REF. : HP-ASPI-MN.1187	
				DATE : 20/03/02	PAGE : 1/4
COMPTE RENDU DE REUNION / MINUTES OF MEETING				LIEU / PLACE : ESA	
OBJET / PURPOSE :			CLASSIFICATION :		
Instrument Splinter meeting ESA Alcatel/Alenia/Astrium + HFI, SPIRE, PACS, HIFI					
PARTICIPANTS ATTENDEES	SOCIETE FIRM	SIGNATURE SIGNATURE	PARTICIPANTS ATTENDEES	SOCIETE FIRM	SIGNATURE SIGNATURE
See attached					
REDACTEUR / WRITTEN BY : G.Lund					
CONCLUSION :					
Review of warm units accommodation. Instrument critical items Change process					
For each point, actions taken to freeze interface					
Next meetings decided:					
03-avr	Alcatel	SPIRE accommodation			
04-avr	Alcatel	HIFI Accommodation			
09-avr	Astrium	Herschel FPU thermal Industry (TBC)			
10-avr	Astrium	Herschel FPU thermal Industry + Instruments			
<u>DISTRIBUTION</u> : PARTICIPANTS / ATTENDEES	POUR ACTION : FOR FURTHER ACTION		PACS (O.Bauer), HIFI (K.Wafelbaker), SPIRE (K.King), HFI (J.Charra) ESA (G.crone), Astrium (K.Moritz, E.Hoelzle), Alenia (M.Sias, M.Cesa), Alcatel (G.Lund, J.P.Chambelland, B.Collaudin, P.Rideau)

H-P INTERFACE MEETING - ESTEC
WITH instruments

Herschel / Planck QPM Instruments Splinter meeting

**HERSCHEL HIFI PANEL -Y-Z
RECONFIGURED AFTER MEETING ON 08.03.02**

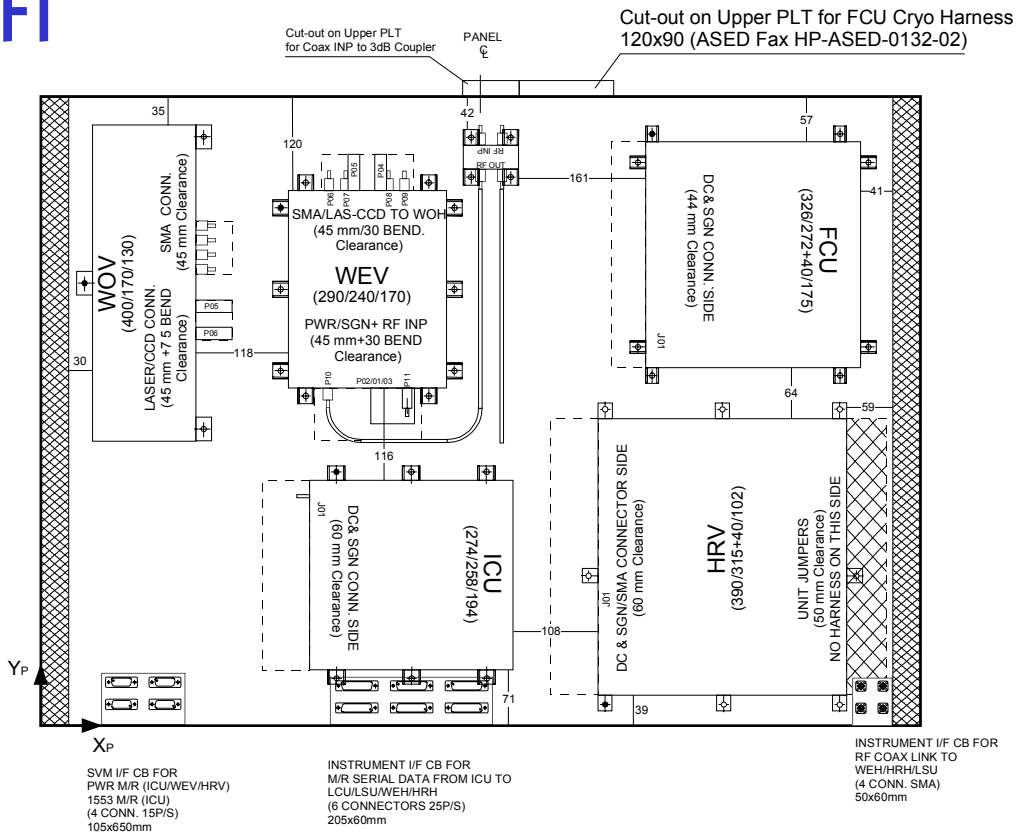
→ proposed update accommodation shown (vug).

↳ heated discussions.... HIFI insists on the importance of:

- temp. reqts of WOH/WOV respected
- thermal stability (goal of 1K/hr) being achieved.

HIFI to: confirm dimensional constraints of LSU } HIFI AI-4
provide cable constraints wrt harness }
connections between HAH and HRV }
requirements }

since September 2001 - There is an action on Alcatel/Alenia Alcatel will provide to the instruments Alenia's Alcatel AI-2 preliminary analysis of thermal behaviour of SVM panels, for 25-03-02 as produced for the SAR. This is in the data package but Alcatel will send separately.

This to include temperatures of WBS + HRS weeks 14 and stability requirements. (Temperature: -40° to +10° and 1K per hour)
